**ITEM 63. TRAFFIC TREATMENT – INTERSECTION UPGRADE – DUNNING
AVENUE AND CRESSY STREET ROSEBERY**

TRIM RECORD NO: 2015/005195

Traffic Treatment – Intersection Upgrade – Dunning Avenue and Cressy Street Rosebery

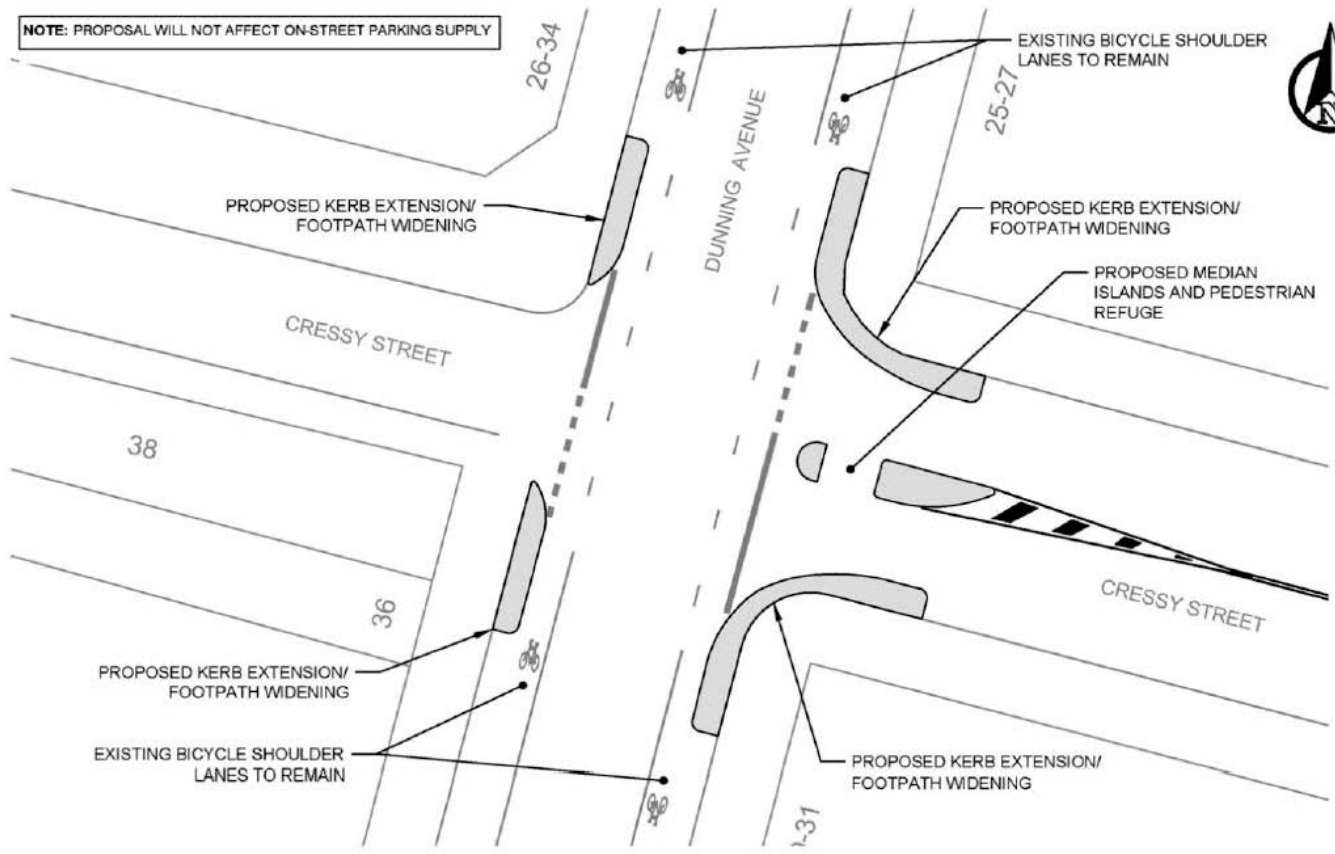
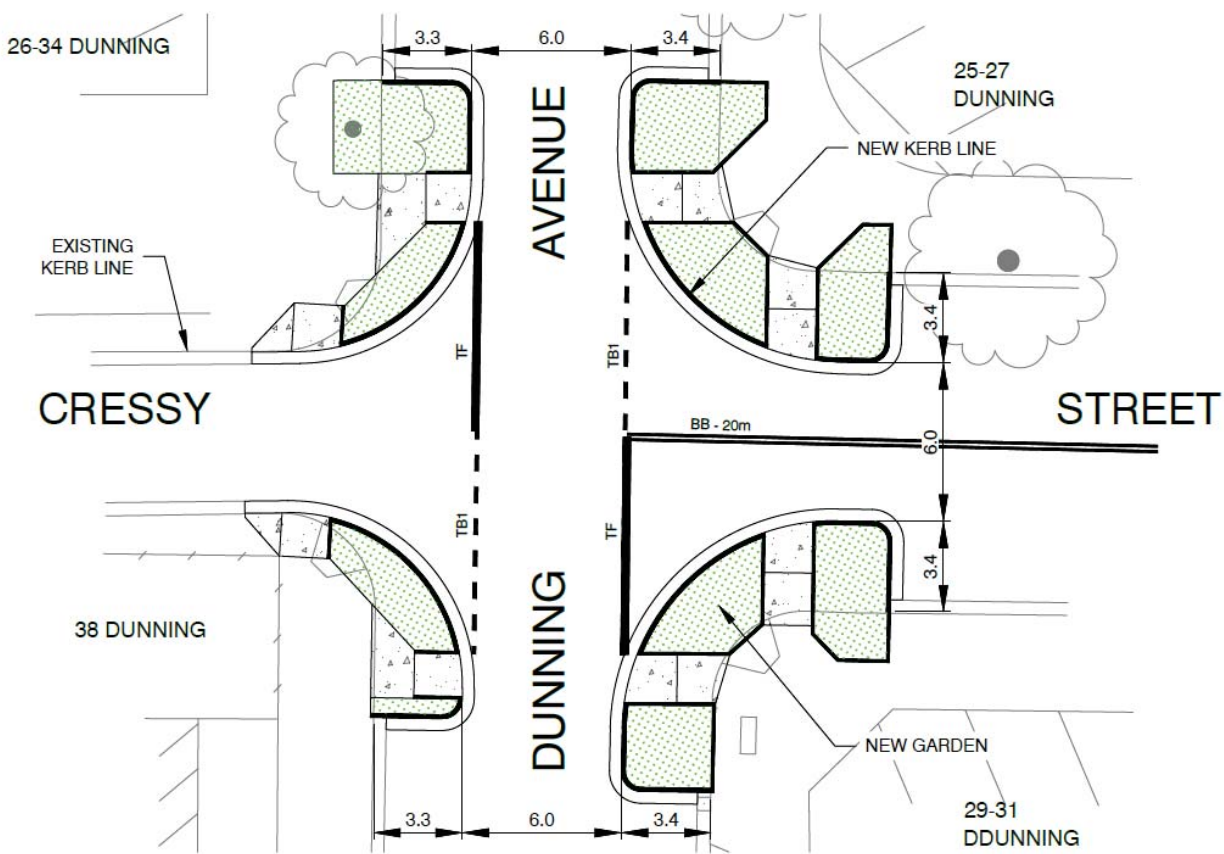
It is recommended that the Committee endorse the following design changes to the treatments proposed at the intersection of Dunning Avenue and Cressy Street in Rosebery:

- (A) Widen footpath extensions on the north-eastern and south-eastern corners; and
- (B) Removal of central median in Cressy Street, east of Dunning Street.

Following a review at the detailed design stage, the proposal has been updated to include widening of kerb extensions on the north-eastern and south-eastern corners of the intersection. The proposed widening will include the removal of the median island proposed previously in Cressy Street, east of Dunning Avenue.

The revised proposal is consistent with existing treatments for intersections in Rosebery and will enhance safety by narrowing lane widths and turning radius to reduce vehicle speeds approaching the intersection.
